ADA Curb Ramp New Construction Inspection Form (Parallel)

NW Timeric

23885.56

NW Lenox

PARALLEL RAMP (PL)

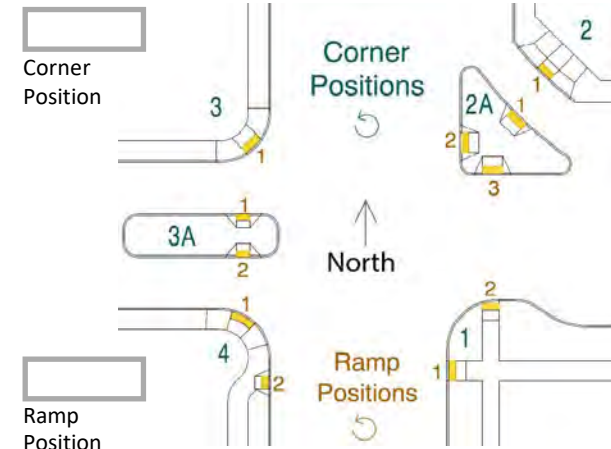
NO DWS Fail RR and Turn Space
